TR - 031022 (P)
RE-OPEN

Subject: City of Marysville Project No. R-9701
State Avenue Widening: 116th Street NE to 136th Street NE
116th Street NE Grade X-ing Improvements: Request for Amendment of Order/Petition

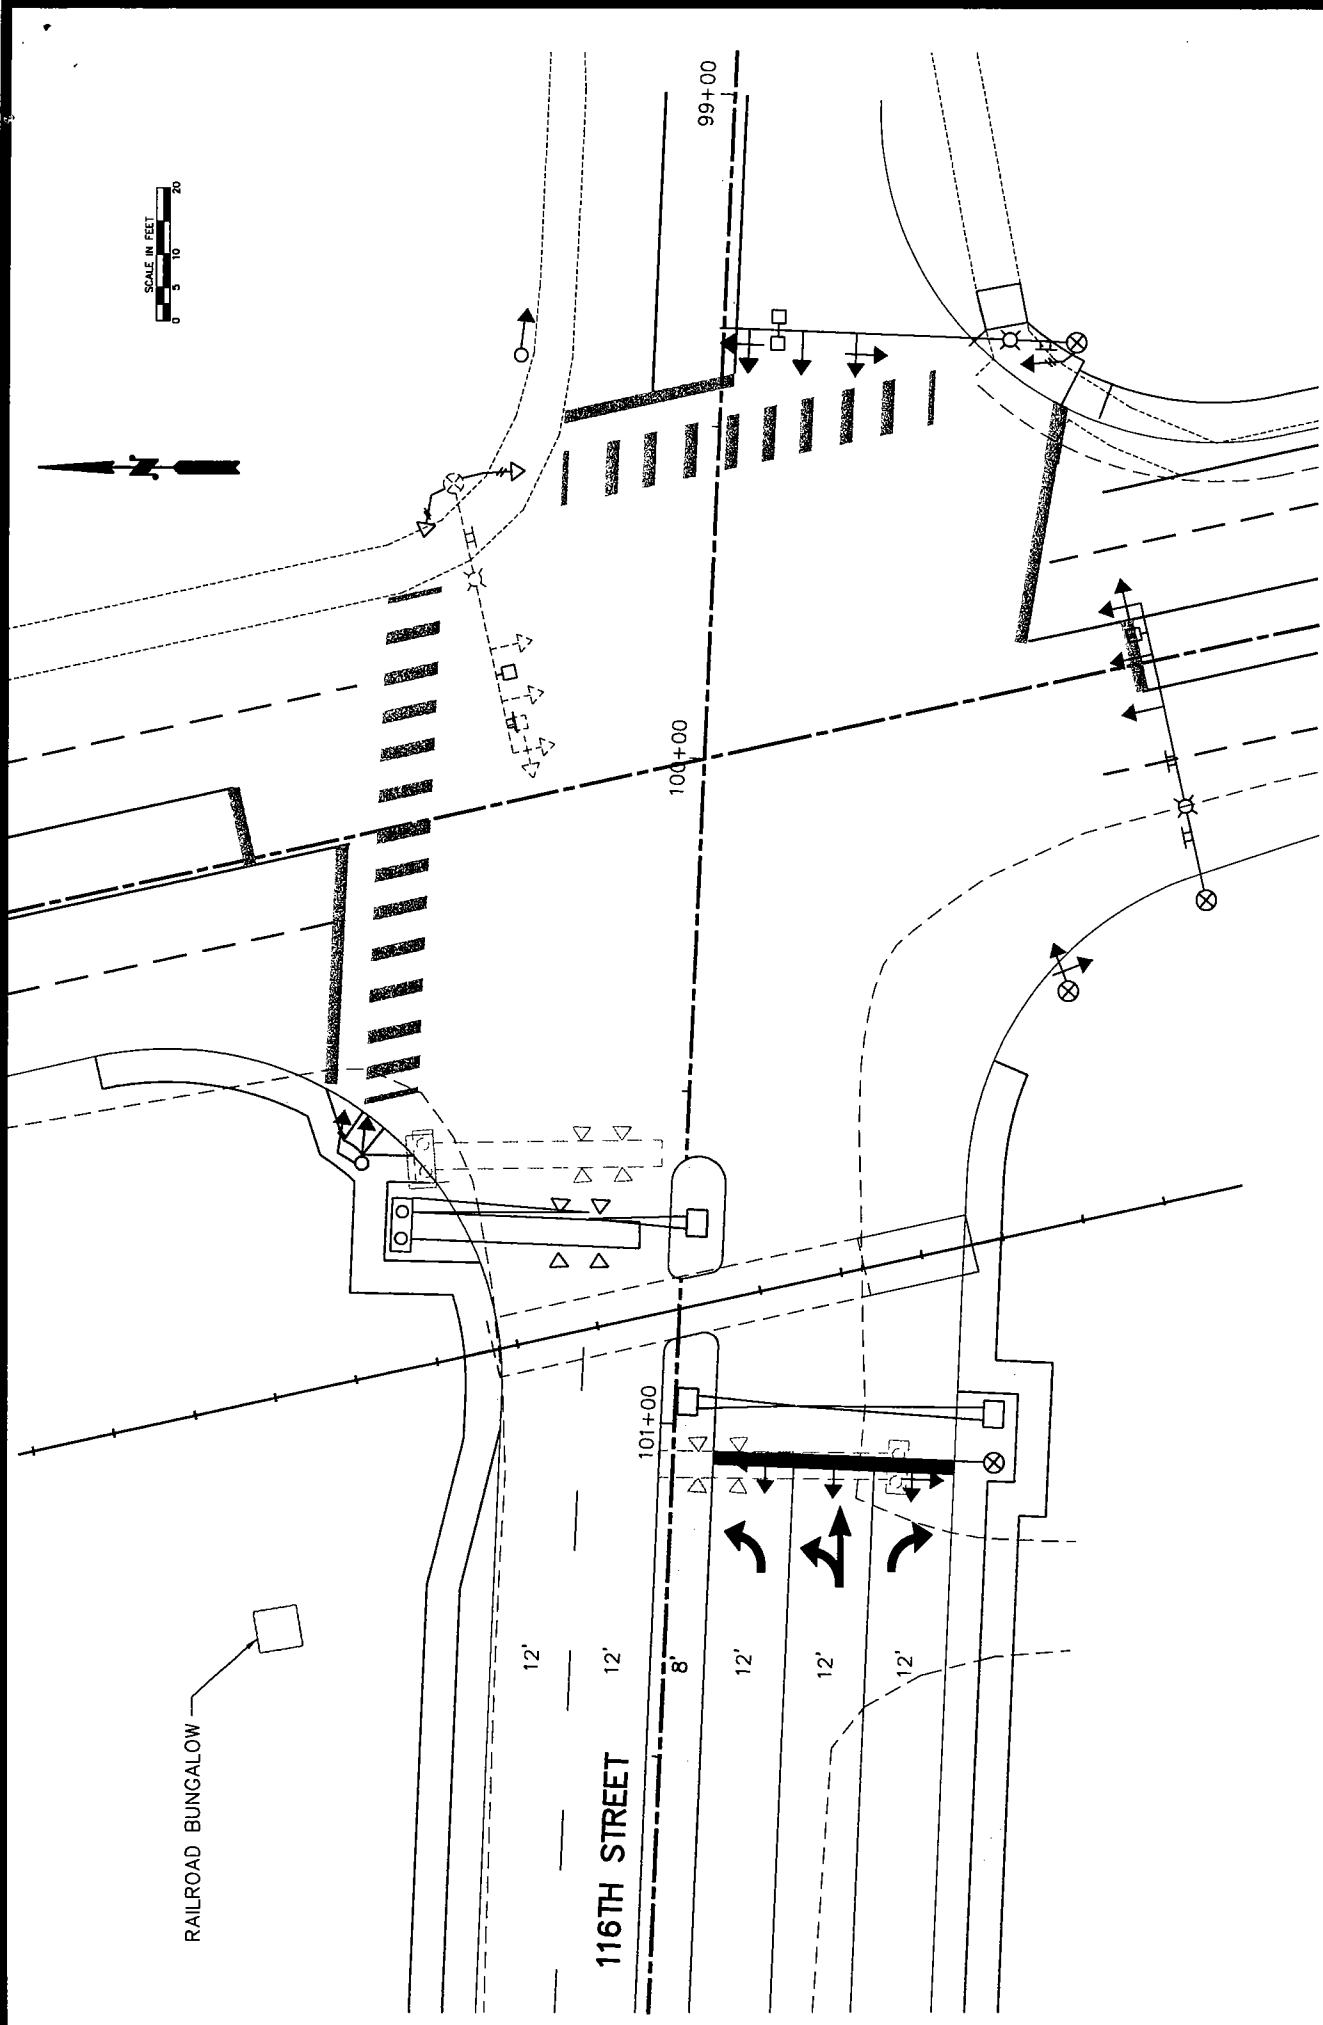
As we discussed, the original Order granted the City and BNSF authority to move forward with improvements, based on a three-lane configuration, which would have given way to installation of a pre-signal and replacement of the existing cantilever signals with shoulder-mounted signals. This was proposed as a means of addressing line-of-sight conflicts which would otherwise have existed between BNSF's "cants" and the City's own signal improvements. With today's request, we ask that you now consider amending the Order to include the following:

1. Widening of the crossing surface and configuration from three (3) to five (5) lanes, as shown, including six foot shoulders and sidewalk on both sides of 116th. This would result in two (2) through lanes in the westbound direction, one (1) through lane in the eastbound direction, an eastbound right-turn only lane, and an eastbound left turn only lane.
2. Addition of median gates and signals/flashers for both approaches, as shown, to be housed within an eight (8) foot median.
3. Installation of cantilever-mounted signals on the westbound approach due to the new through lane.

To reiterate, and in response to your question, shoulder-mounted signals would be installed coincidental with gates at both median locations and on the south. Please don't hesitate to call me if you have additional questions or comments. I would greatly-appreciate it if you could keep me apprised of progress on this item. Thank you again for all of your assistance during the course of this discussion.
